**SDG&E 5/24/11 Response**  
**A. 10-06-007 South Bay Substation Relocation Project PTC**  
**Energy Division Data Request 05 Dated May 4, 2011**  
**SDGE-ED-005: Q**

**Project Alternatives**

# GIS Substation Alternative Description and Preliminary Impact Analysis

## South Bay Substation Relocation Project

**Figure 1: North of J Street General Constraints**

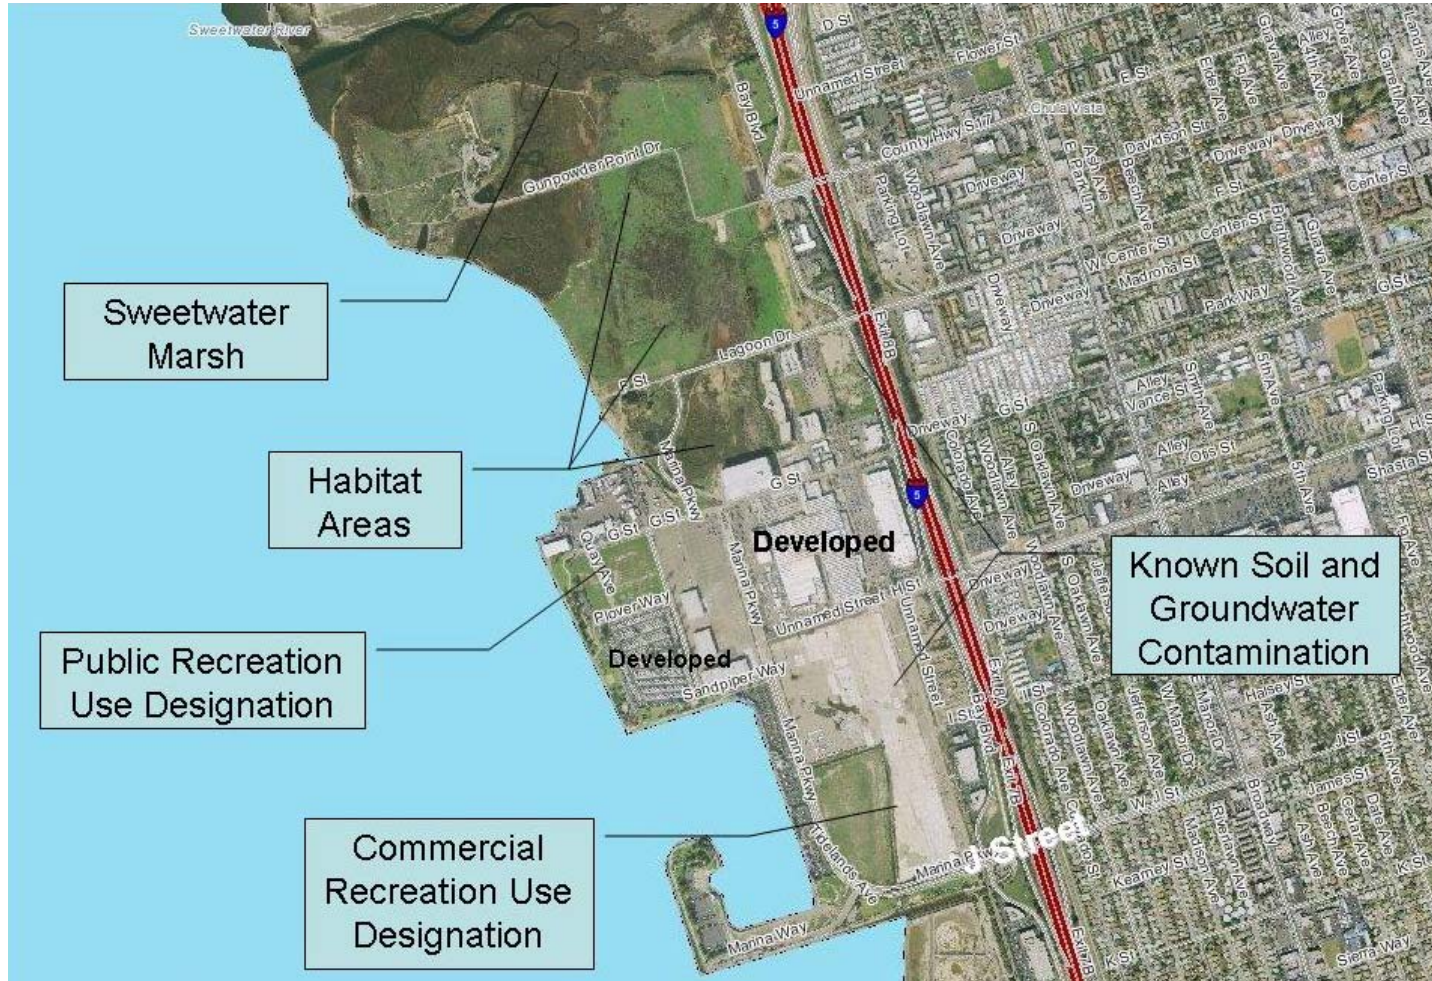
Sites located to the North of J Street – In the data request letter provided by SDG&E on August 16, 2010, areas north of J Street were not considered to be a potential Project alternative due to parcel size, hazardous substance contamination, and direction provided by the Port of San Diego and City of Chula Vista that the South Bay Substation Relocation should be located toward the southern portion of the Master Plan, south of J Street.

Please clarify the location of sites that were considered but rejected from further evaluation as a feasible Project alternative. The response should include a map identifying the wetland buffer areas proposed by the master plan, as well as areas known to contain serious subsurface and groundwater hazardous substance contamination in relation to sites that were considered but rejected for further evaluation. Include a discussion as to why groundwater levels would result in a Project site being potentially infeasible from a design and operation perspective.

Because a primary objective of the South Bay Substation Relocation Project is to move the substation south of its existing location, SDG&E never considered and/or rejected any specific locations north of J Street. SDG&E only considered the specific parcels identified in the PEA, none of which were located north of J Street. The statements contained in the August 16, 2010 data response explain why no specific sites North of J Street were considered. This is because, as stated in the above question, the San Diego Unified Port District and City of Chula Vista had directed SDG&E toward the southern portion of the Master Plan area. In response to CPUC Data Request Number 1, SDG&E conducted a cursory review of the area north of J Street and identified some general characteristics that appeared to make the area additionally infeasible for the relocation of the substation. Figure 1: North of J Street General Constraints illustrates the issues that were identified for this area after the CPUC asked SDG&E about these locations.

## Broadway & Palomar Site

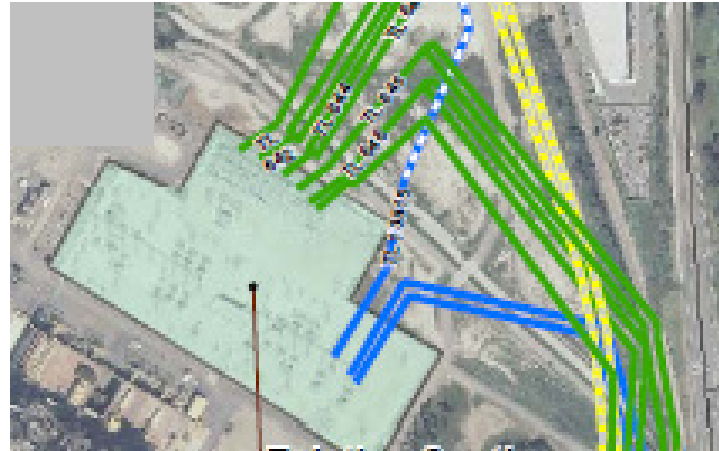
For each of the alternatives presented above and for any additional sites that may have been identified by SDG&E, please provide a map indicating the location of utility tie-in's required for each site, based on a desktop-level review of a potential interconnection to the existing utilities. Please provide a summary regarding the distance for each interconnection from the existing utility lines to the alternative site location. The summary should identify the total linear feet for 69-kilovolt (kV), 138 kV, and 230 kV improvements that would be required for Project alternatives.

647	2,500	Require installing overhead/underground transmission structures along city streets. HDD (Horizontal Directional Drill) to cross I-5 would be required.
